DESCRIPTIVE REPORT

Type of Survey ... Basic Hydrographic
Field No. WH-10-1-84
Registry No. H-10148

State Wisconsin
General Locality .. Lake Superior
Sublocality Chequamegon Bay

HYDROGRAPHIC TITLE SHEET

JD 262-263
VELOCITY + INSTRUMENT ERROR
0 0.1 0.2 0.3 0.4 0.5 0.6

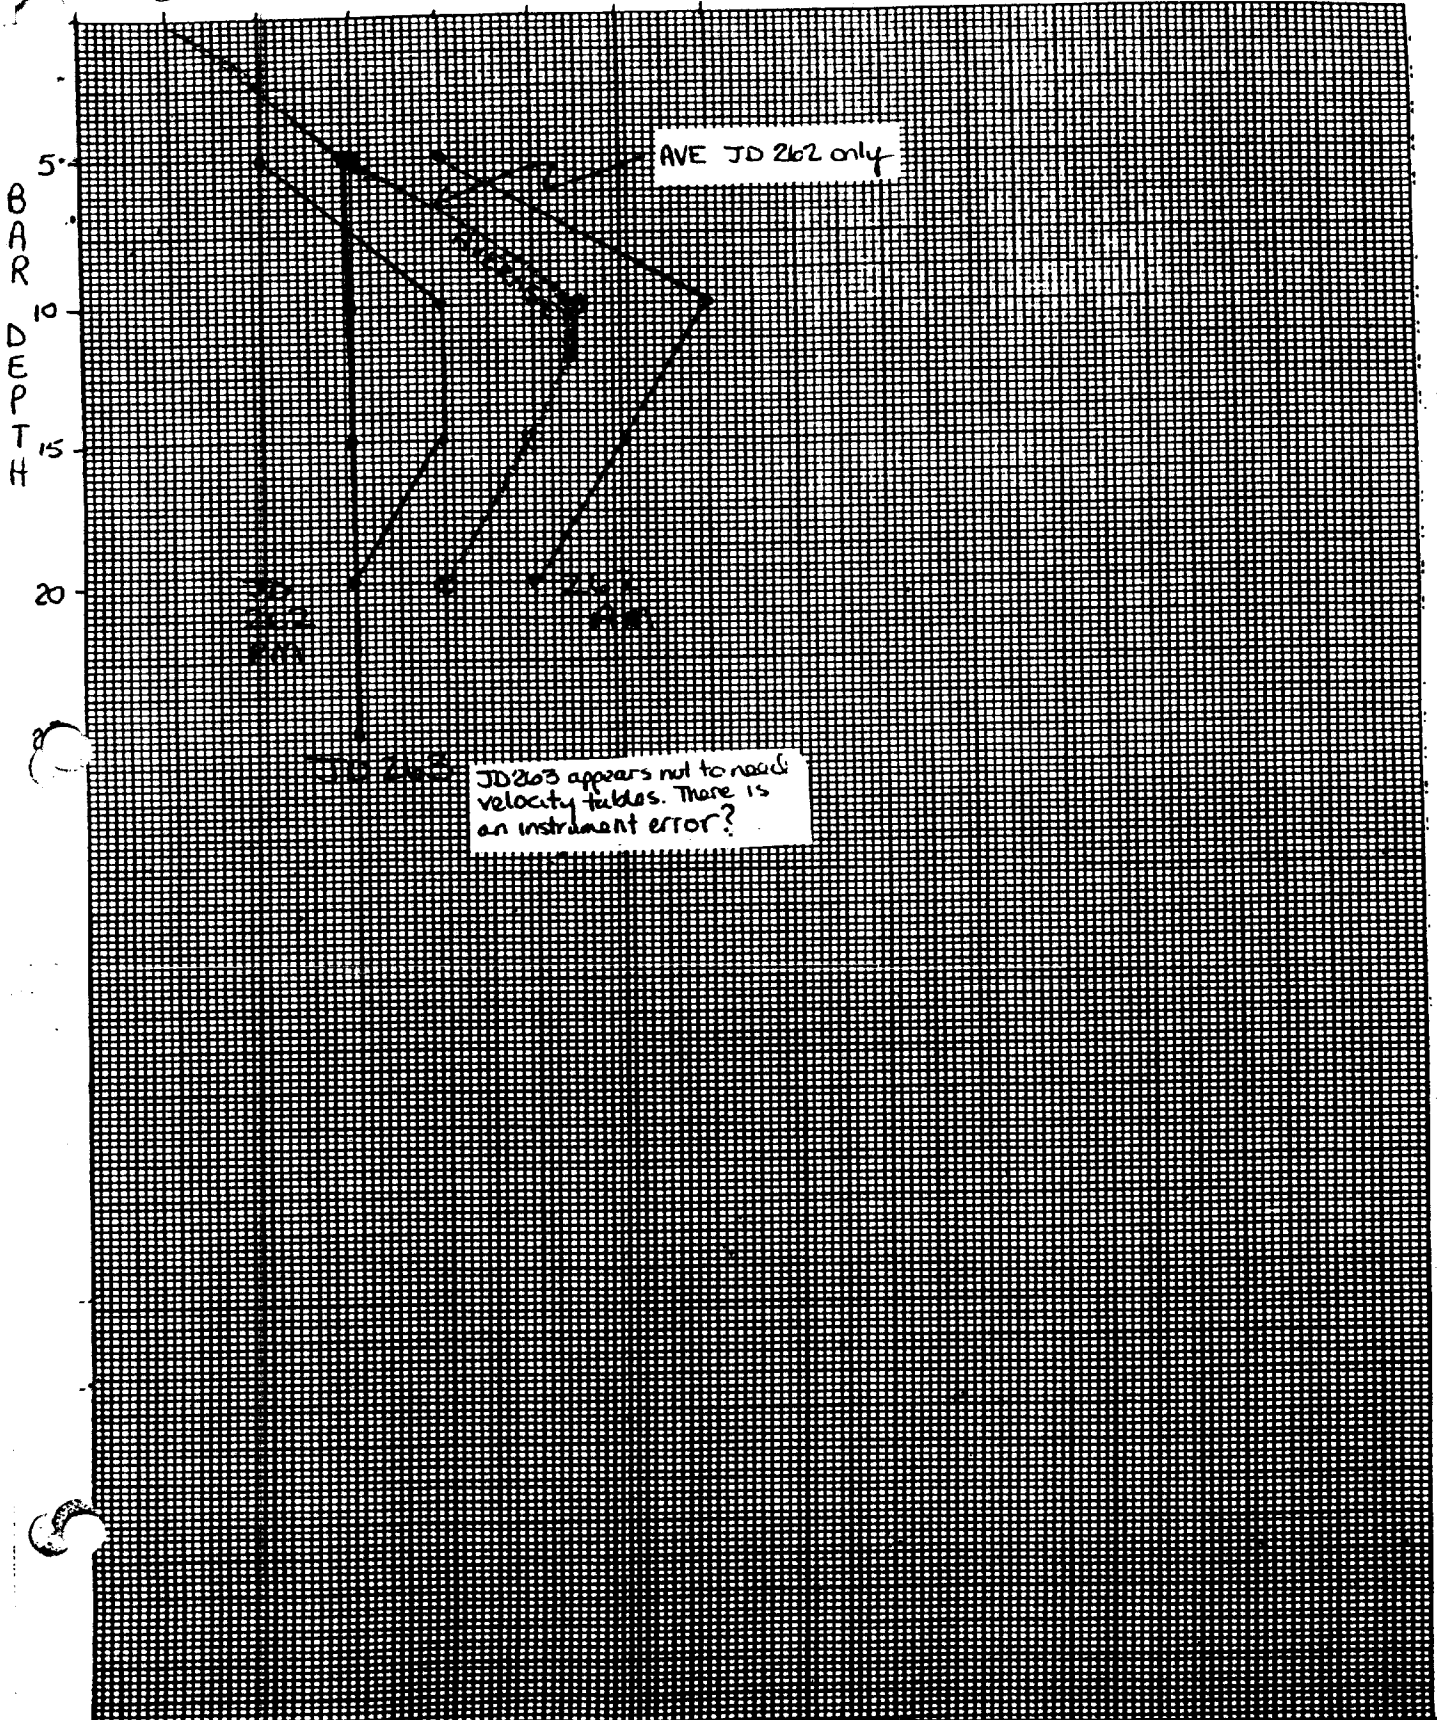
JD 263 appears not to need velocity tables. There is an instrument error?
